SIB 52 05 22

RECALL 22V-670: THIRD ROW SEAT

This Service Information Bulletin (Revision #1) replaces SI B52 05 22 **dated September 2022**.

CAUSE

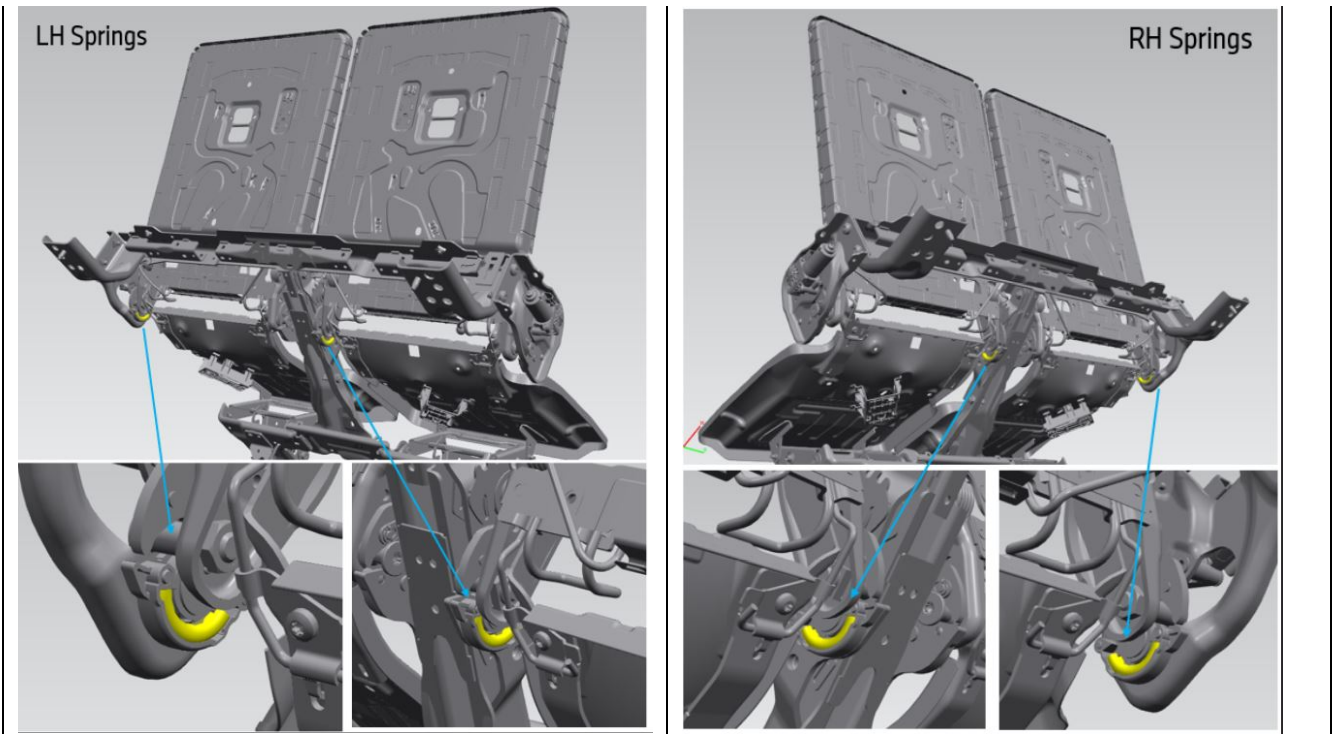
Compression springs that are required for the electric fold function may not be installed correctly or may be missing altogether.

An improperly positioned or missing compression spring prevents the seat backrest from locking completely.

Check the 4 compression springs on the backrest frame of the third-row seats and rework if necessary.

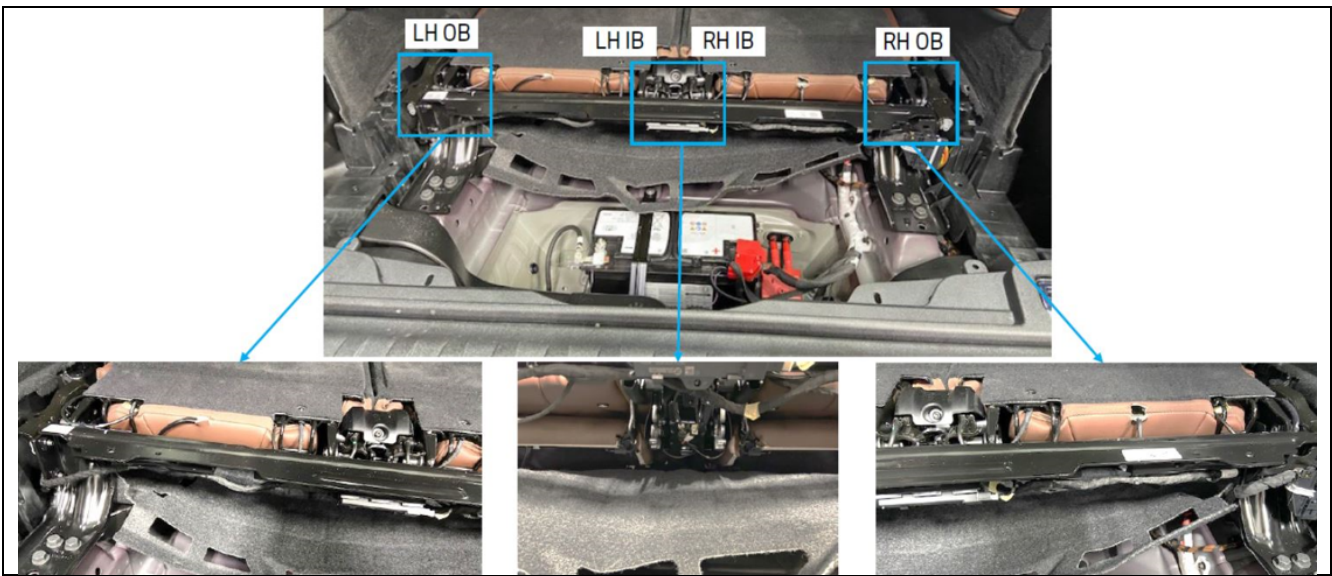
There are 2 springs per seat installed, Underneath the inboard (IB) and outboard (OB) pivot points

You can feel the springs easier than you can see them. Here we are pointing at the Left Hand Inboard (LH IB) compression spring.

This is the view looking from underneath the seat at the Left Hand Inboard (LH IB) compression spring.

Here is a close-up view of a correctly installed compression spring.

The compression spring is missing in this picture.

Check that the 4 compression springs are

correctly installed.

If any of the springs are missing, submit an INFO ONLY TSARA case letting us know how many spring(s) you will need and pictures of the missing spring location.
